# 1242-1248 15TH AVE E

RECOMMENDATION PROPOSAL PACKET - 06/21/2021  
1242-1248 15TH AVE E

#3036562-EG

EARLY DESIGN GUIDANCE

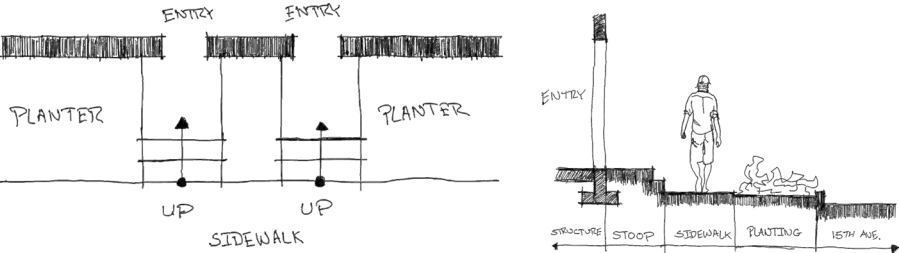
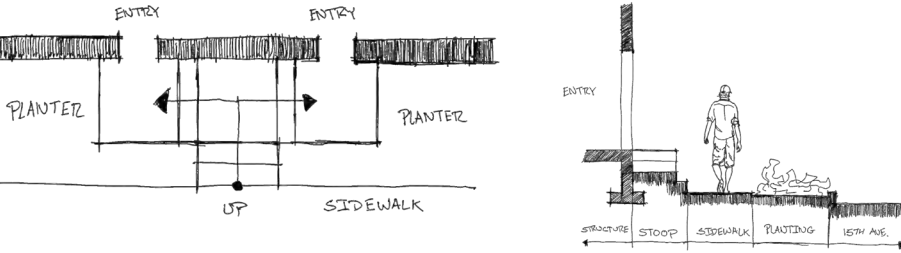
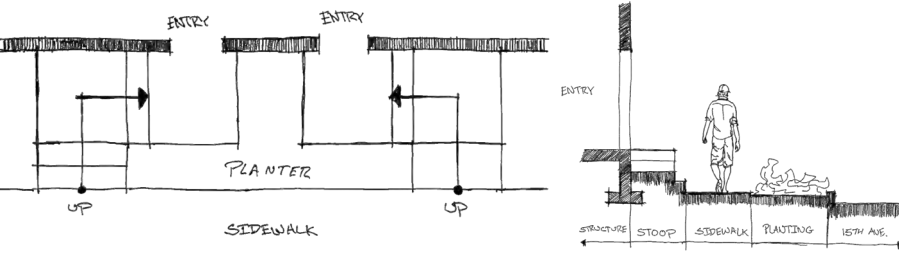
(a). Staff supports the elevated entries of the street-facing units, but directs further development of a usable front stoop and the entry experience in response to earlier guidance: “Staff specifically prioritizes Design Guidelines PL3-A-3, Individual Entries; PL3-A-4, Ensemble of Elements; and PL3-B-4, Interaction. Compose all entries as variations on a set of coordinated elements that contribute to a human-scale. Design front stoops and canopies that are informed by the context, and provide opportunities for personalization and social interaction.” Establish a clear public/private threshold for all entries, including the at-grade entries along the shared central path. (PL3-A-3, PL3-A-4, PL3-B-4, DC2-D-1).

**RESPONSE:** In the limited height and space available the front entry stoops along 15th Ave E have been modified to provide a larger semi-private space by raising the entries above the adjacent sidewalk and providing a turn in the direction of travel. This semi-private space is enhanced through the use of small landscape buffers and bio-retention planters to create a more intimate entry for each unit. Weather protection is provided through the use of steel canopies, while lighting and signage provides safety and direction to each unit. Individualism of each entry comes in the form of a varied material palette as well as the size and scale of the stoop and canopies. Below is a stoop/entry study that shows the pros and cons of each option and what our preferred option is. Images located on the next page show examples of our preferred option throughout the neighborhood.

CIRCULATION DIAGRAM

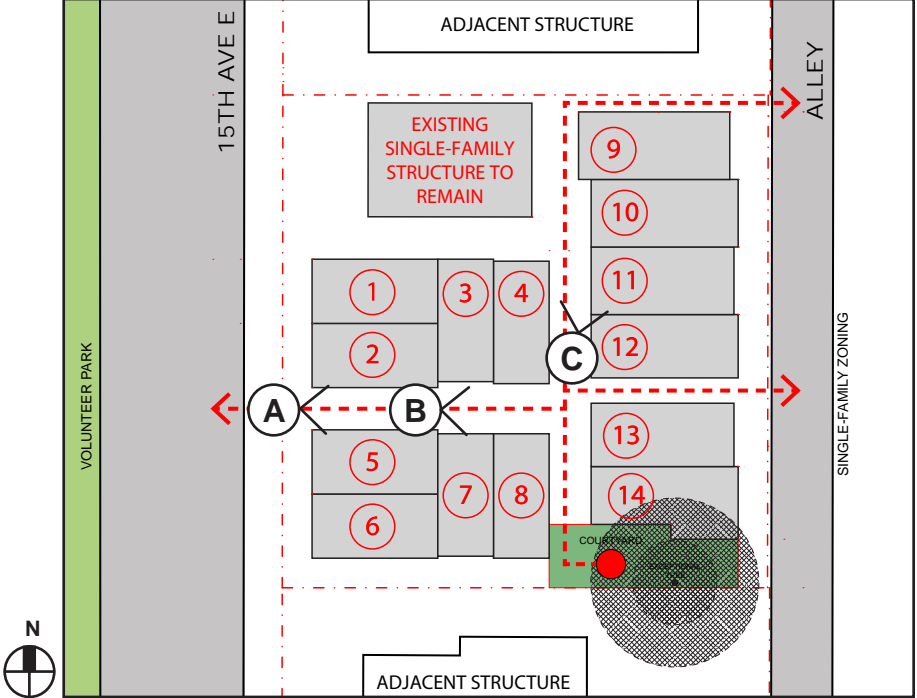
(b). Staff sees merit in both the north path option and central path option - the applicant's preferred - as illustrated in the studies provided on page 58 of the second EDG packet. Staff supports the central path option if the two secondary entries of units 2 and 5 are eliminated, designed so as not to appear to privatize the shared path. As stated in the first EDG review, "design the shared path to be generous, welcoming, and identifiable." (PL3-A, DC2-A-1).

**RESPONSE:** The central path option has been kept from the second EDG proposal as it is the only option that provides the ability to have an accessible route through the site as well as the ability to create the larger courtyard integrated with the existing exceptional tree. The design of this path has been developed further to provide a more generous and welcoming space that directs a visitor to their final destination. In doing so the secondary entries of units 2 & 5 have been removed to reduce the appearance that this central path will be privatized by those units.

COURTYARD LOOKING SOUTHEAST

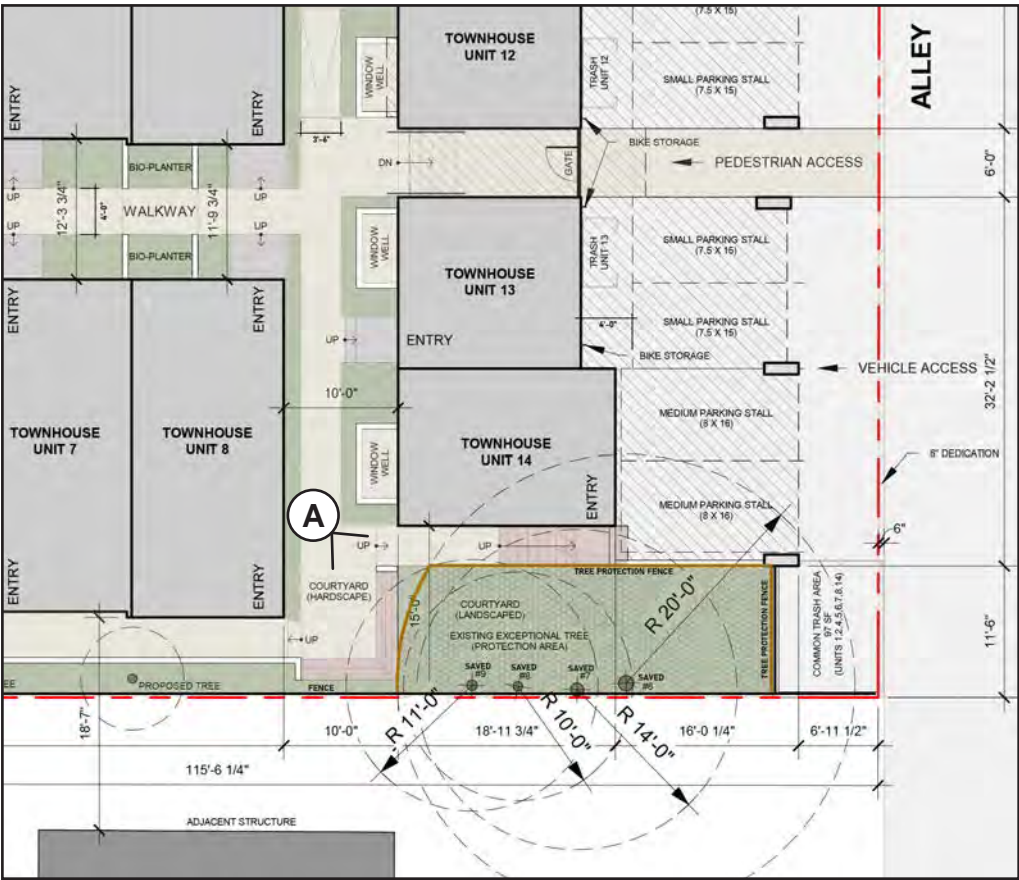
- (c). Staff continues to support the retention of the existing Exceptional tree and the intent to incorporate the tree into an amenity area. Staff supports the intent to retain tree numbers 7, 8, 9, 12, and 13 along the south property line, as described on page 13 of the second EDG packet, and specifically prioritizes Design Guidelines CS1-D-1, On-Site Features. (CS1-D-1).

- (d). Staff continues to note the lack of bio-retention planters in the landscape plan. Consider stormwater requirements and the impact on site design. Downspouts should be well integrated into the facade composition and correctly located to correspond with bio-retention facilities. (DC4-D).

- RESPONSE:** The proposal is to retain and protect the exceptional tree located at the southeast corner of the site. Trees 7, 8, and 9 along the south property line will also be saved.

- RESPONSE:** Both the proposed landscape plan and site plan have been updated to show locations of all bio-retention facilities. These facilities and the associated downspouts have been integrated into the design of the site and structures to become features and place making elements.
